# ***SERVICE PROCEDURE***

**G-08505  
JULY 2008**

**SUBJECT: SAFETY RECALL (U.S.)  
REMOTE POWER MODULE (RPM) on certain  
INTERNATIONAL® 3000, 4000, 7000, 8000, CXT,  
MXT, ProStar model trucks and IC® CE, HC bus  
models built 11/21/00 thru 5/21/08 with one or more  
RPMs.**

Figure 1.  
Fused Wire Cable Installation on a Pre-2007 Emission  
Engine

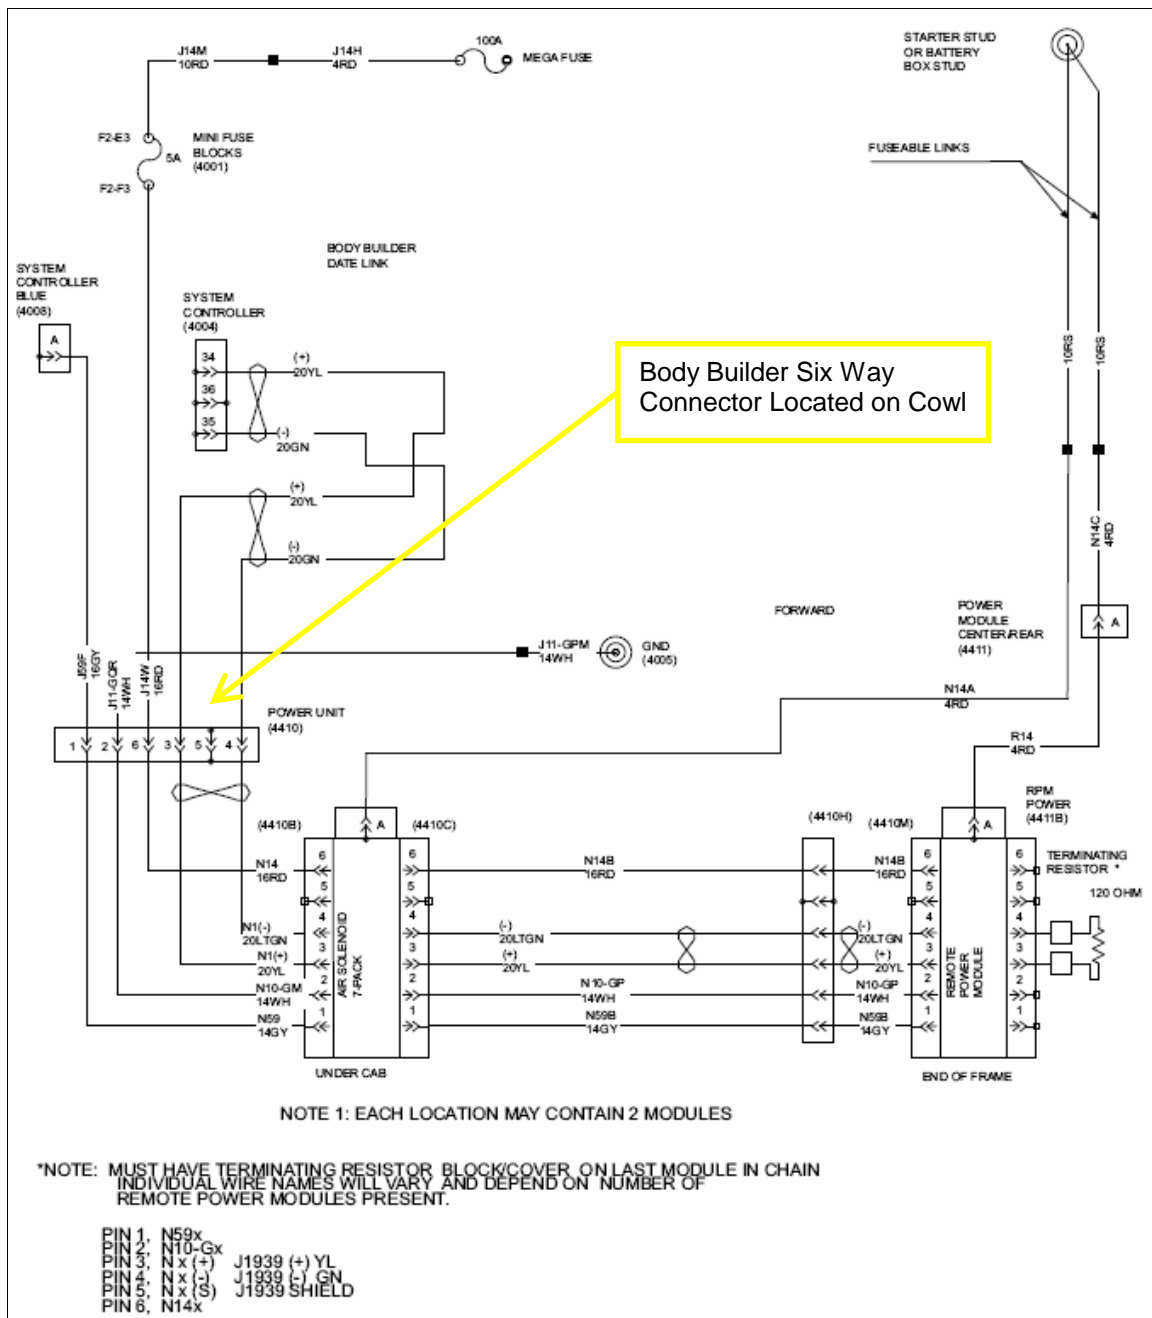
Locate the body builder six-way connector located under the hood and install a 2597844C91 fused wire cable in this circuit as shown in Figures 1 and 2. Use tie straps as needed to route the lengthened harness.

Figure 3.  
Fused Wire Cable Installation on a  
Remote Power Module

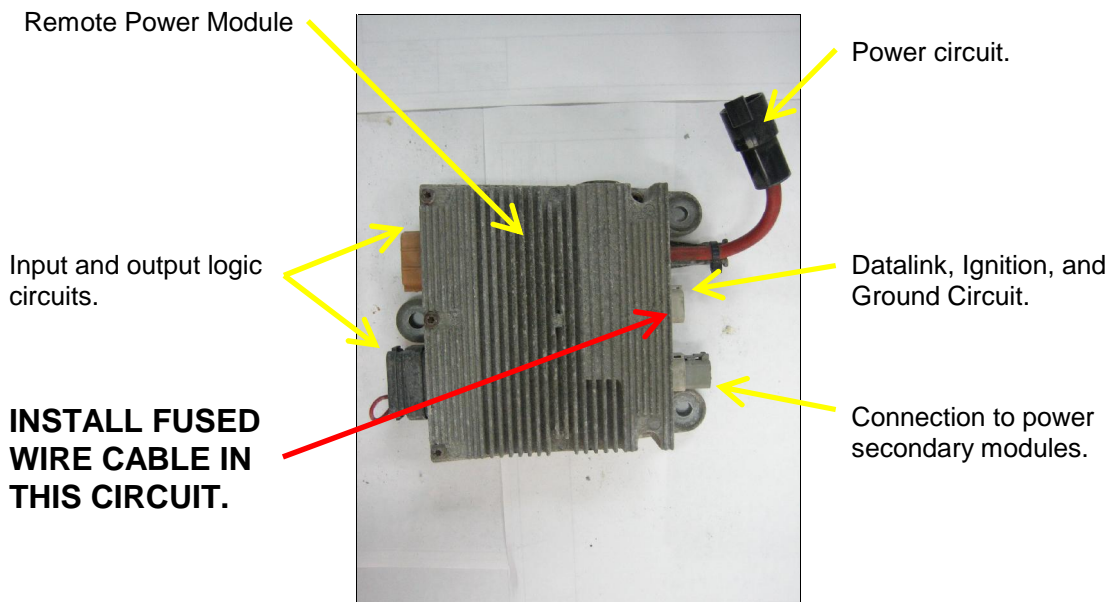
For each RPM that is powered directly by the vehicle batteries, install a 2597844C91 fused wire cable in the circuit as shown in Figures 3 and 4. Use tie straps as needed to route the lengthened harness.
